## LETI – ‘work in progress’ draft full consultation response

This document outlines LETI’s current draft response (as of 24.03.21), we thought that it might be helpful for others that are putting together a full detailed response. This is an evolving document and intended to be a helpful starting point for others.

## Section A: Non-Domestic Buildings

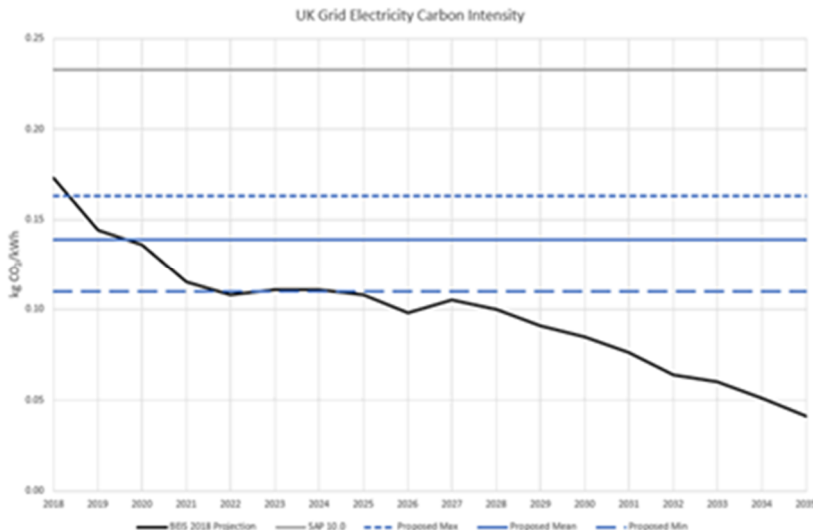
*The proposed carbon factor for electricity is around the current level, so will already be outdated by the time the new guidance comes into effect.  
CO<sub>2</sub> factor should be long term forecast, not 3-year forecast*

*It appears the methodology does not support electricity as the primary energy source as it shows it with a PE factor of 1.501, vs gas of 1.130. This is likely to lead to gas being favoured.*

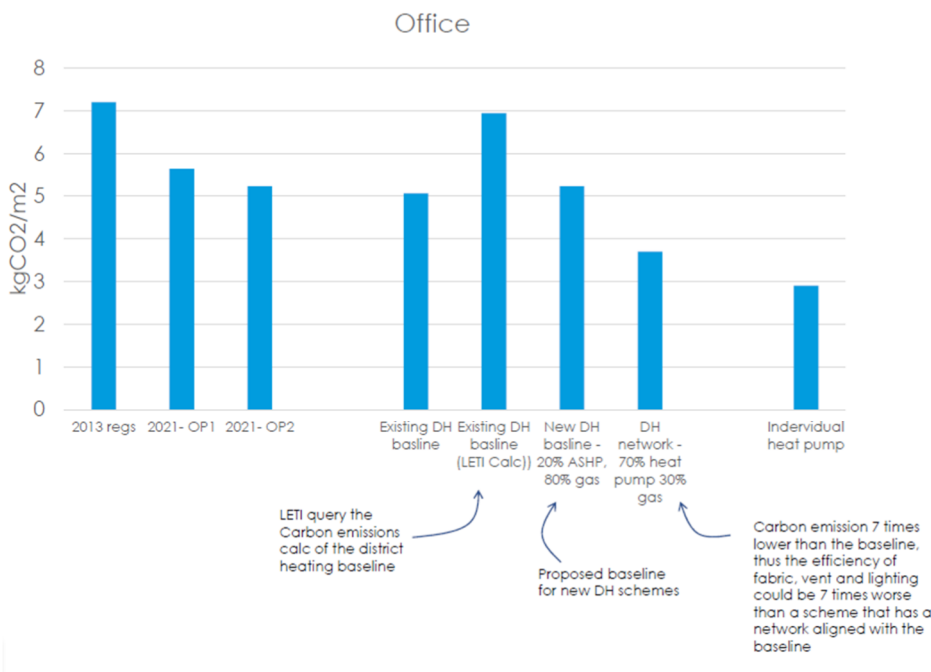
*If the notional building has a fixed DH baseline, and the existing or new network performs better than this, this gives a 'get out clause' for all buildings connecting to DH*

- New/ existing district heating schemes will have varying carbon factors depending on % and efficiency of heat pumps
- If the notional building has a fixed DH baseline, and the existing or new network performs better than this, this gives a 'get out clause' for all buildings connecting to DH
